1. Current design analyze regarding noise
2. Further design check regarding remaining noise
3. General Layout improvement

(current design for the LM4871 on all PCBs)

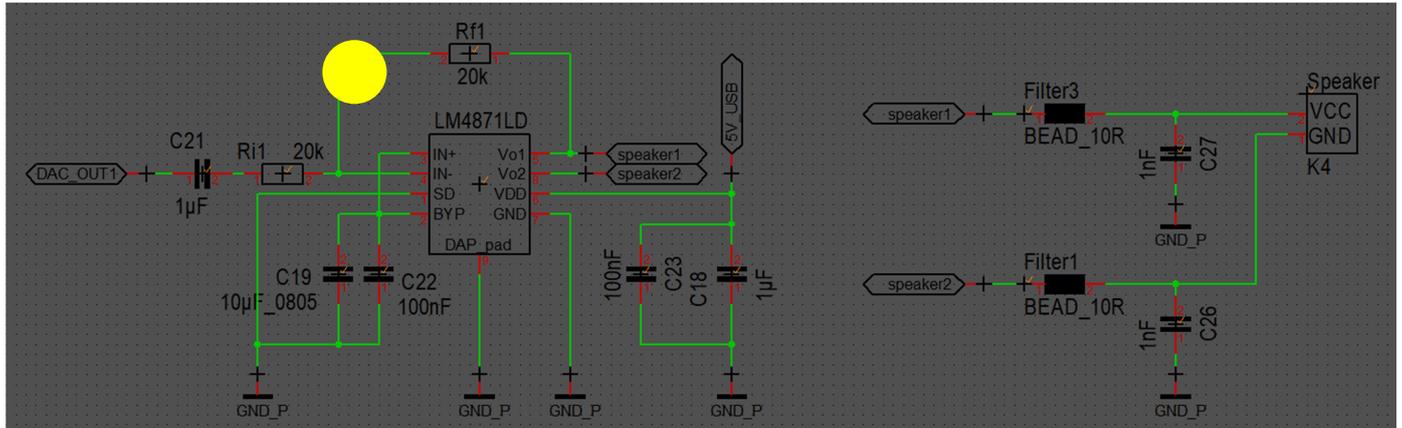
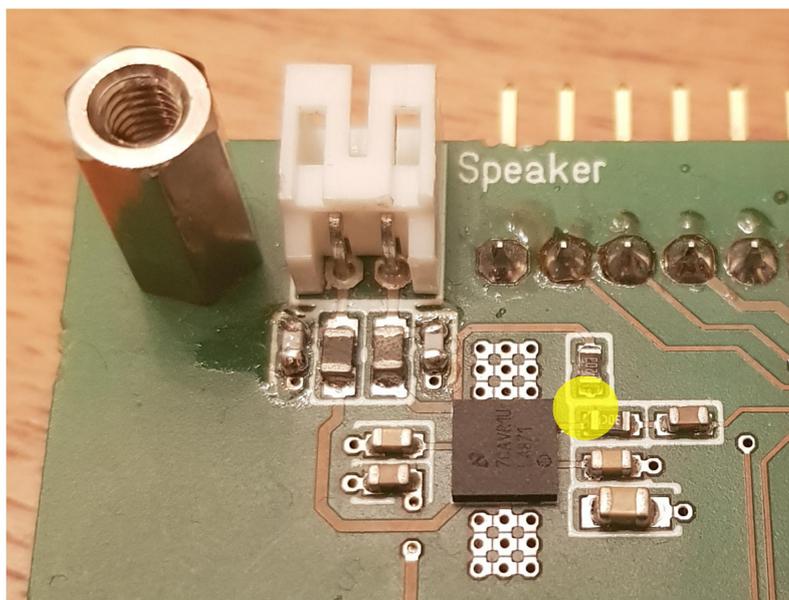
A STM32F405 reads data from wav-files of a µSDcard and applies the voltage over the internal 12bit DAC to the LM4871. The sound output is overlain by a “scratchy” noise. The shown schematic is used on different PCBs. Some show that noise and others do not show that noise. Touching the yellow marked area on the PCB removes the noise almost completely.

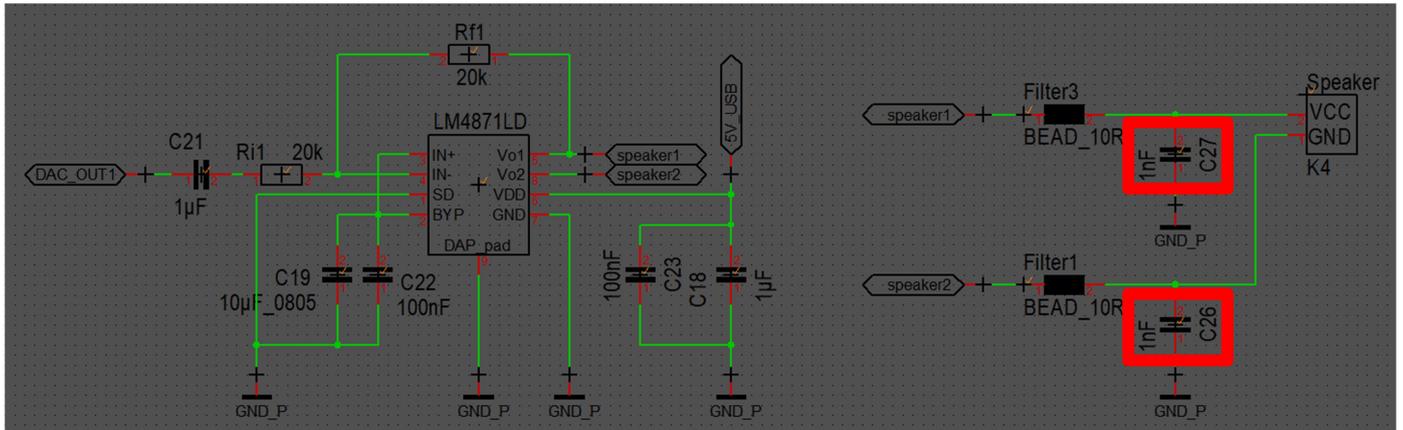
The noise disappears completely when the two red marked capacitors are removed. The right part of the schematic (beads and capacitors) was found on some sources on the internet to “improve the audio output”. As mentioned in the LM4871 datasheet an additional improvement is not needed but we thought it would be good. It was not unfortunately...

Can you give some more insight why this behavior may occur?

When the two marked capacitors are removed the sound quality improved on all PCBs with the LM4871.

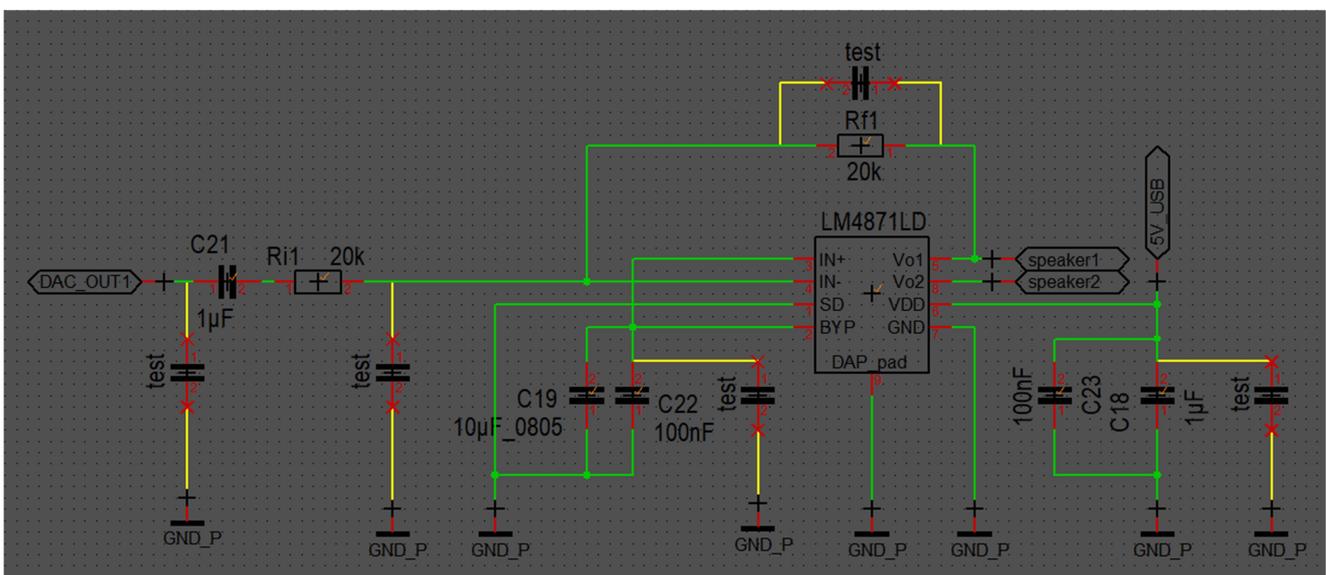
The main noise problem is solved, but we recognized that there is still some small scratchy sound left when you are close to the speaker with your ear when the audio output signal of the STM32 is forced to constant 1650mV ( $VCC/2 = \text{mean sinus}$ ).

Replacing the remaining beads with 0R resistors has no effect.

We placed some additional capacitors on various places around the LM4871 as shown in the picture. Only one “test” capacitor was soldered on the PCB at once. We tested 48pF and 680pF. Both values had no effect on the remaining noise. Is it possible that that remaining noise is generated internally by the LM4871?

When the sound volume is increased, the remaining noise remains constant (it is not amplified). When sound is played and the volume is loud enough the remaining noise is inaudible.

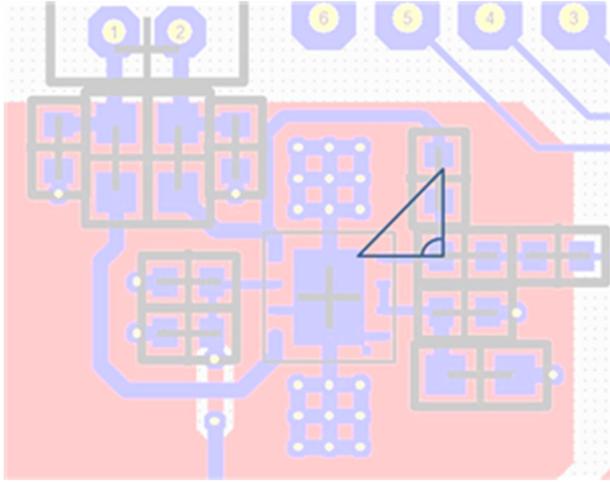
You mentioned the layout improvement regarding the (to avoid) 90° traces at Ri and Rf.

This is the TI layout example from the datasheet (figure 29, page 13). I think you prefer this placement and traces?

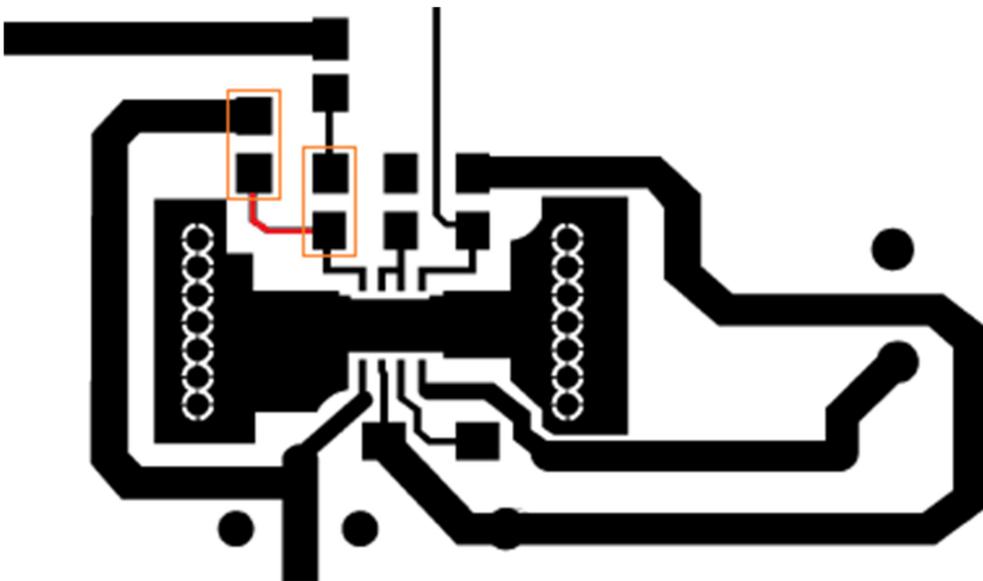
Can you give more insight why to avoid the 90° angle as shown above?

I noticed that there is no GND connection of the pins directly to the exposed pad underneath the chip. As you can see in our schematic we connected PIN 1 and 7 “the short way” directly to the GND exposed pad. Should we avoid that? Maybe you can give some more insight here, too.
